From: [Robert Herz - MCDOTX](#)
To: [Craig Sharp \(csharp@buckeyeaz.gov\)](mailto:csharp@buckeyeaz.gov)
Cc: [Gordon Tyus](#)
Subject: Case 16-08 Comments
Date: Wednesday, July 06, 2016 11:50:12 AM
Attachments: [Case 16-08 Detail 391-1 Mark-up 2016-07-06.pdf](#)

DETAIL NO.
391-1

VALVE BOX INSTALLATION
AND GRADE ADJUSTMENT

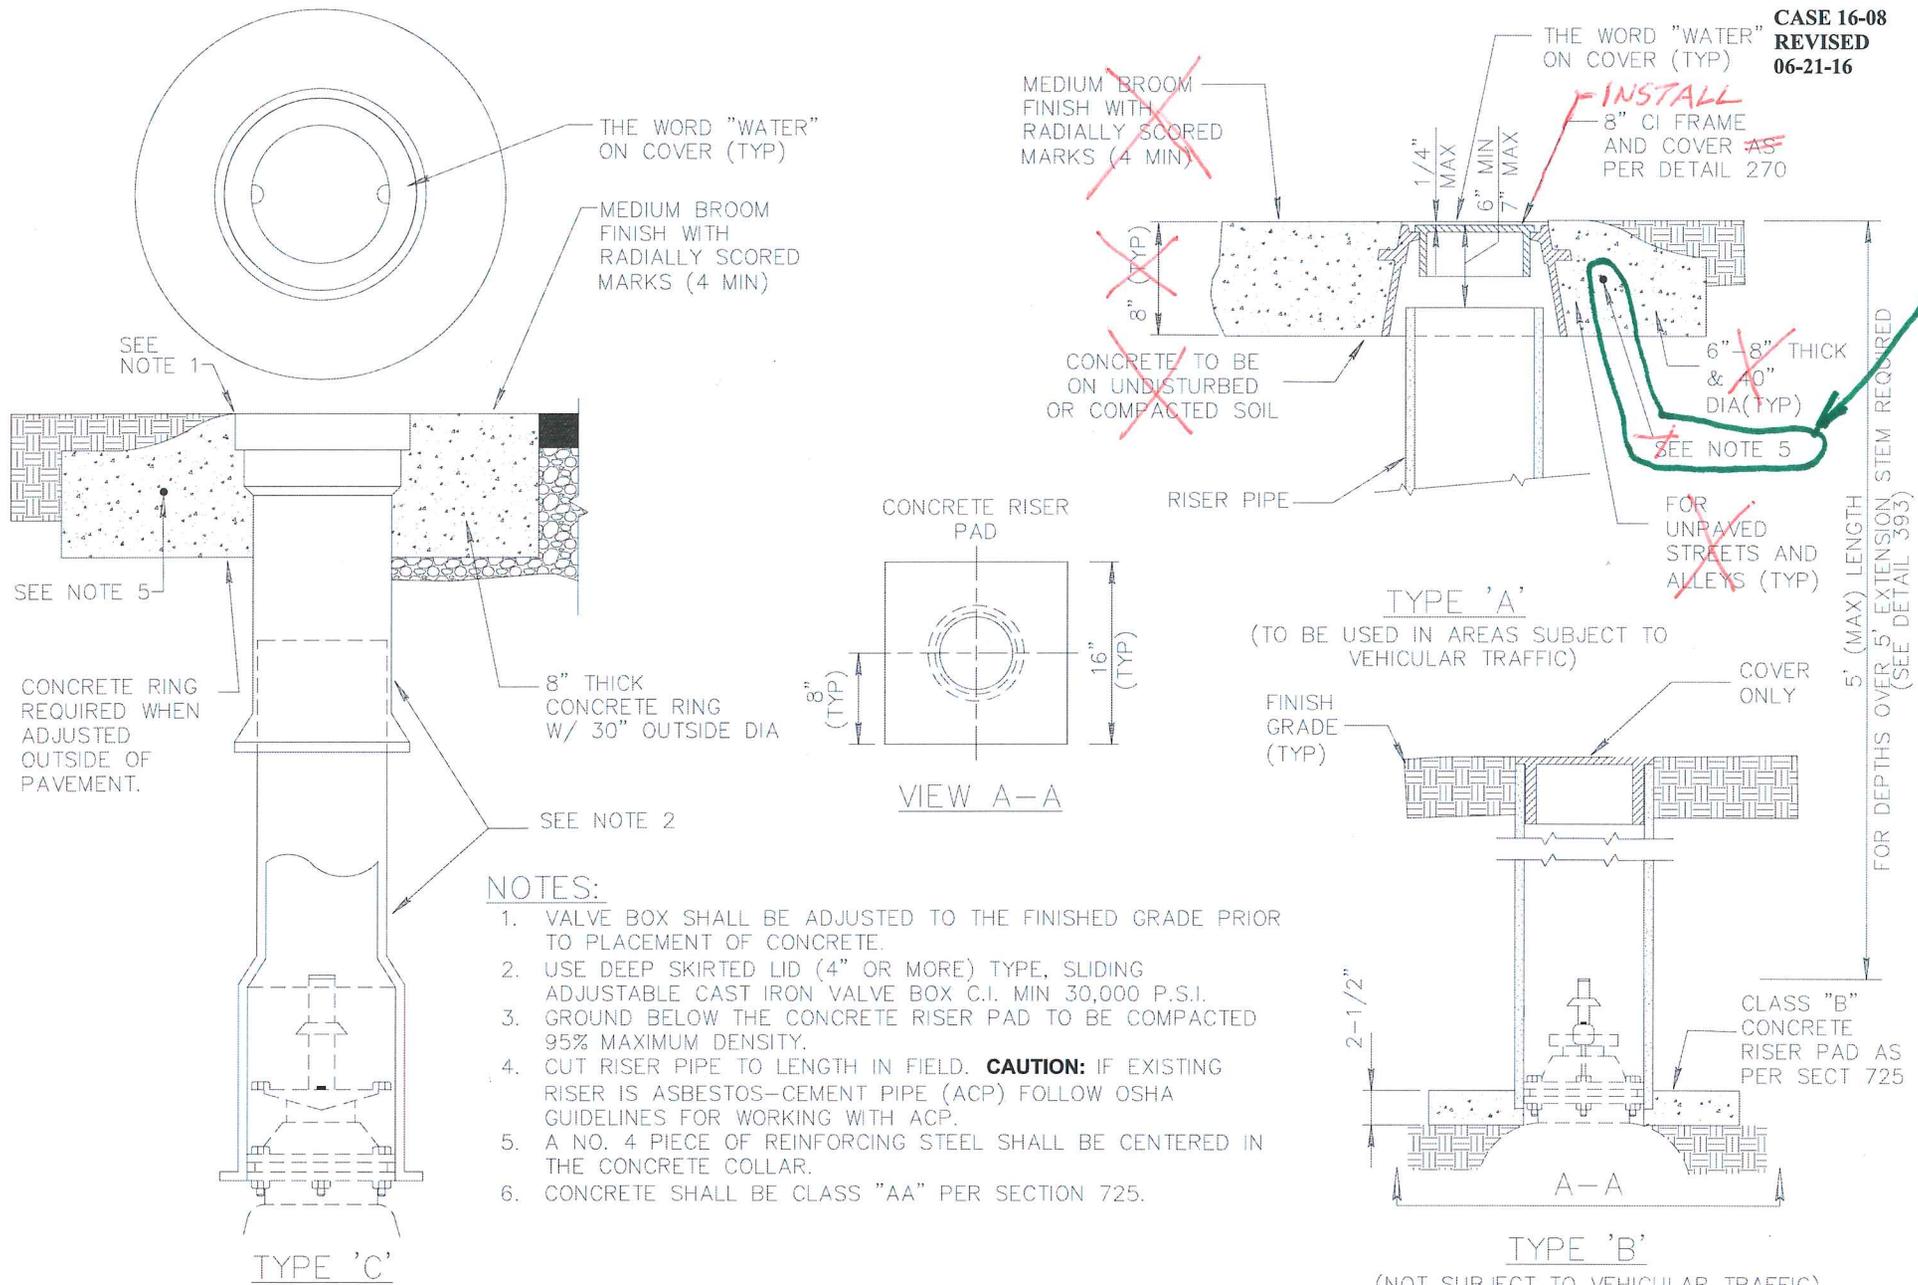
The TYPE 'A' drawing in Detail 391-1

1. Coordinate with Detail 270 by adjusting the callout 8" CI FRAME AND COVER AS PER DETAIL 270 to read INSTALL 8" CI FRAME AND COVER PER DETAIL 270 and then delete callouts that duplicate those on Detail 270 (See attached file).
2. Rebar is shown in the concrete ring for unpaved conditions with note: SEE NOTE 5. This revision, if desired, should be shown in Detail 270.
 - a. Is the rebar (as shown) desired only in areas subject to traffic that are unpaved?
 - b. The requirement in NOTE 5 should be adjusted to identify the reinforcing steel as a #4 HOOP with the hoop diameter identified. The hoop diameter should be within the range of 27" \pm 3" – use whatever diameter is commonly provided.

The TYPE 'C' drawing in Detail 391-1

1. Rebar is shown in the concrete ring for unpaved conditions with note: SEE NOTE 5.
 - a. Is the rebar (as shown) desired only in areas subject to traffic that are unpaved?
 - b. The requirement in NOTE 5 should be adjusted to identify the reinforcing steel as a #4 HOOP with the hoop diameter identified. The hoop diameter should be within the range of 21" \pm 3" – use whatever diameter is commonly provided.

IN CONFLICT W/ DET 270
